PRODUCT UPDATE

Number: #163
By: LEMO USA
Date: June 8, 2016

New Earthing Cone Design K,E,T,V and W Series

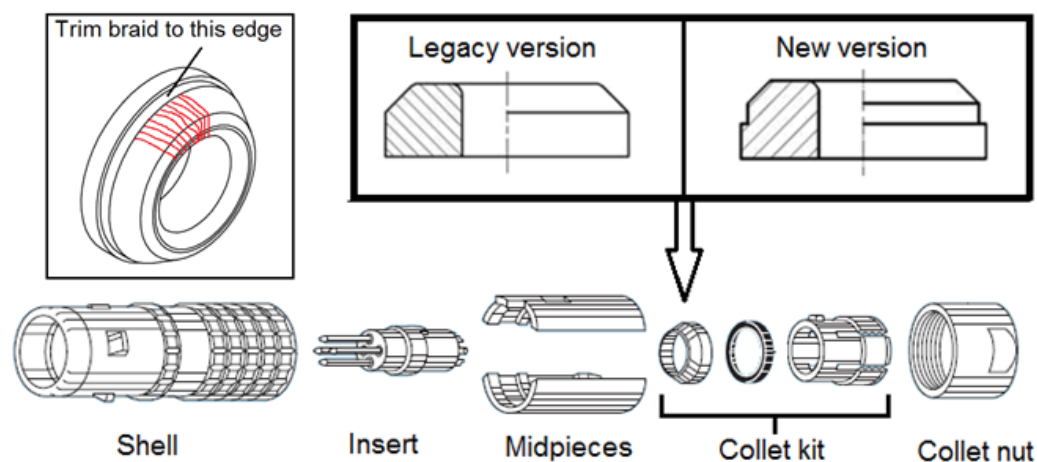
- LEMO has modified the design of the earthing cone used in the water-resistant cable mount connectors to allow more space for termination of the cable braid and to provide an indicator for where the braid should be trimmed.
- Size 1 in each Series (1K, 1E, 1T, 1V and 1W) will be modified first, followed by sizes 0, 2, 3, 4 and 5.
- There is no impact on the other internal parts of the plug or free receptacles.
- No change to part numbers.
- No change to price.

The new earthing cone design allows for improved termination of the cable shield. The shield is folded over the outside of the cone and is trimmed to the edge as shown below.
